## GFA AIRWORTHINESS DIRECTIVE

- SUBJECT:** Cracking of front mounting brackets of C of G (winch) release.
- BACKGROUND:** See attached Grob Service Bulletin MSB 315-62
- DOCUMENTATION:** Luftfahrt-Bundesamt (LBA) Airworthiness Directive No 2002-067 and Grob Service Bulletin No MSB 315-62 form part of this AD.

**Airworthiness  
Directive  
2002-067**

## SERVICE BULLETIN NO. MSB315-62

**Caution:** Illustration below is only for G 103A TWIN II ACRO ! For other models a different arrangement is possible !

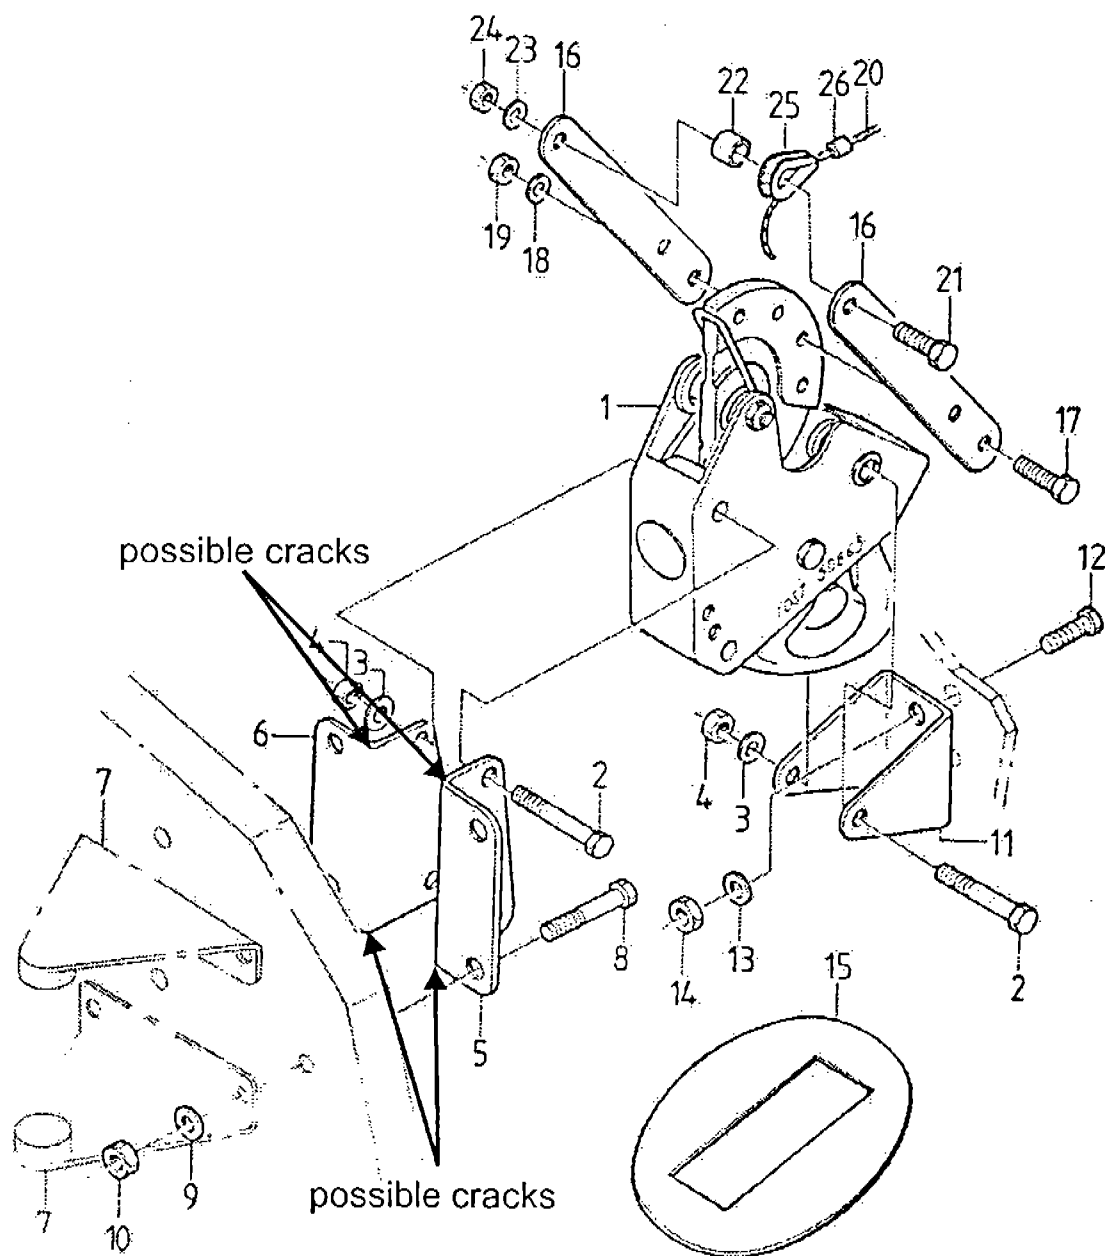
After long time of operation (i.e. towing using the C of G release hook) cracks at the forward C of G release hook attachment brackets might occur.

**1.8.1** The attachment brackets P/N 103-2235.03 and 103-2235.04 or 103B-2360.01 and 103B-2360.02 must be checked for cracks as follows:

- remove rear seat
- check the brackets for possible cracks, refer to illustration on page 2 (if necessary use mirror and pocket lamp)

- remove rear seat
- remove L/H and R/H instrument panel cover
- remove **front** attachment of the C of G hook (item 2, 3, 4), loosen rear attachment (item 12, 13, 14)
- remove attachment brackets (page 2, item 5 and 6)
- install new brackets P/N 103B-2360.01/2 and 103B-2360.02/2

**1.8.2** Both forward C of G release hook attachment brackets must be replaced as follows:

**Caution:** On TWIN ASTIR and TWIN ASTIR TRAINER the additional plate P/N 103-2360.02 must be installed below the attachment brackets.
